Appeal Statement

South Caldecotte Development Proposal: The development of the site for employment uses, comprising of warehousing and distribution (Class B8) floorspace (Including mezzanine floors) with ancillary B1a office space, general industrial (Class B2) floorspace (Including mezzanine floors) with ancillary B1a office space, a small standalone office (Class B1) and small café (Class A3) to serve the development; car and HGV parking areas, with earthworks, drainage and attenuation features and other associated infrastructure, a new primary access off Brickhill Street, alterations to Brickhill Street and provision of Grid Road reserve to Brickhill Street.

Planning Application: **19/01818/OUT**
Appeal Reference – **APP/Y0435/W/20/3251121**

Highways England
Woodlands
Bedford
MK41 7LW

Figure 3: 2023 Baseline +Committed +Proposed Development Traffic AM 800-900 hrs

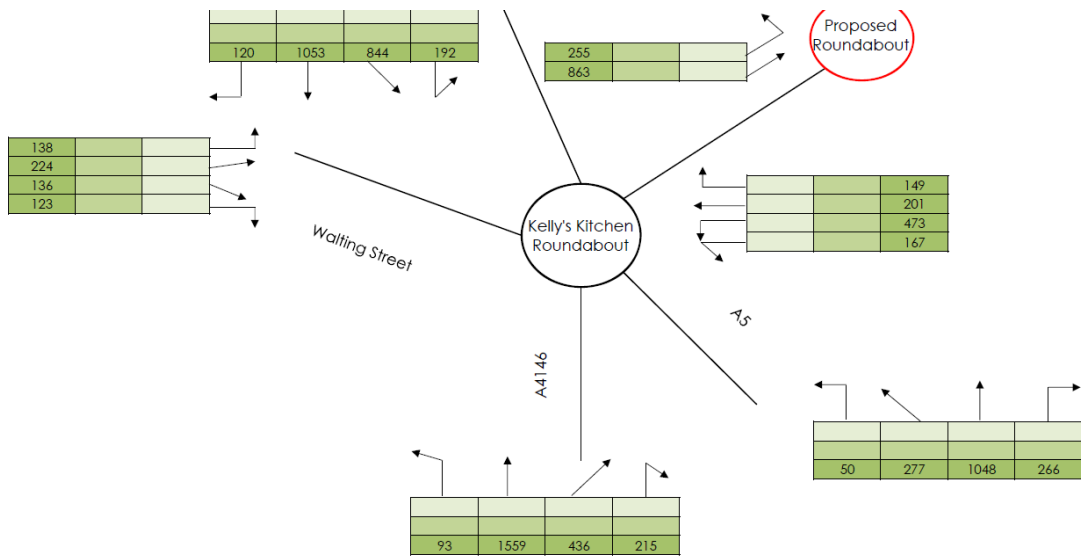
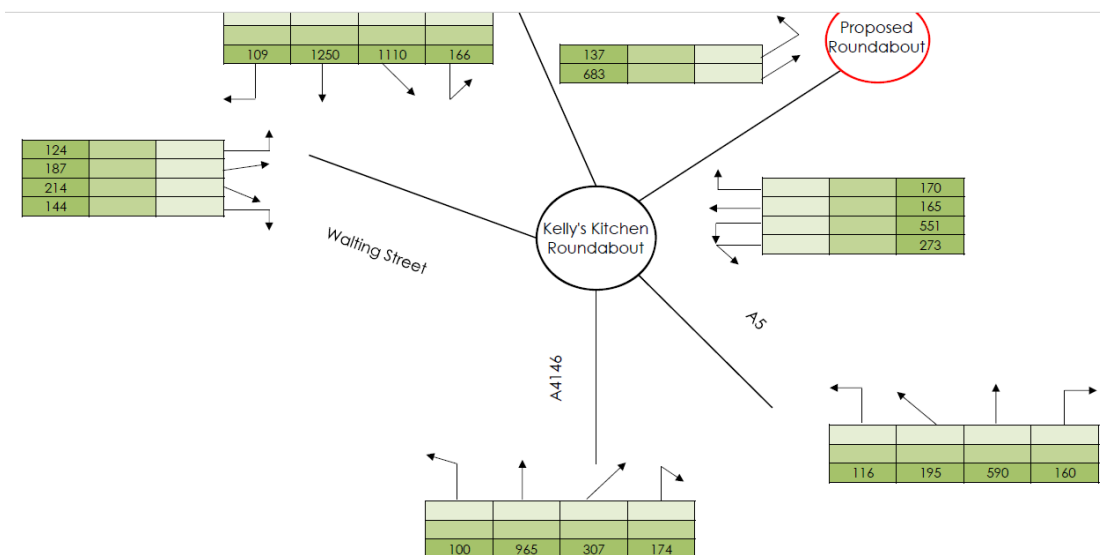
18. The revised TA was reviewed, and we are satisfied that this document gave an acceptable representation of the proposed developments impacts (Technical Note 08). The TA showed the proposed development was expected to generate approximately 428 and 327 vehicular traffic during the morning and evening peak hours respectively. These figures are made up of 86 and 84 HGV vehicles during the respective peak hours on the highway network.
19. Trip distribution diagrams below (Figure 3 and 4) taken from the TA show the predicated traffic to and from the proposed development site that will route through Kelly's Kitchen Roundabout. During AM and PM peaks, a total of 1,118 and 820 vehicles are moving towards the V10 Brickhill street respectively.
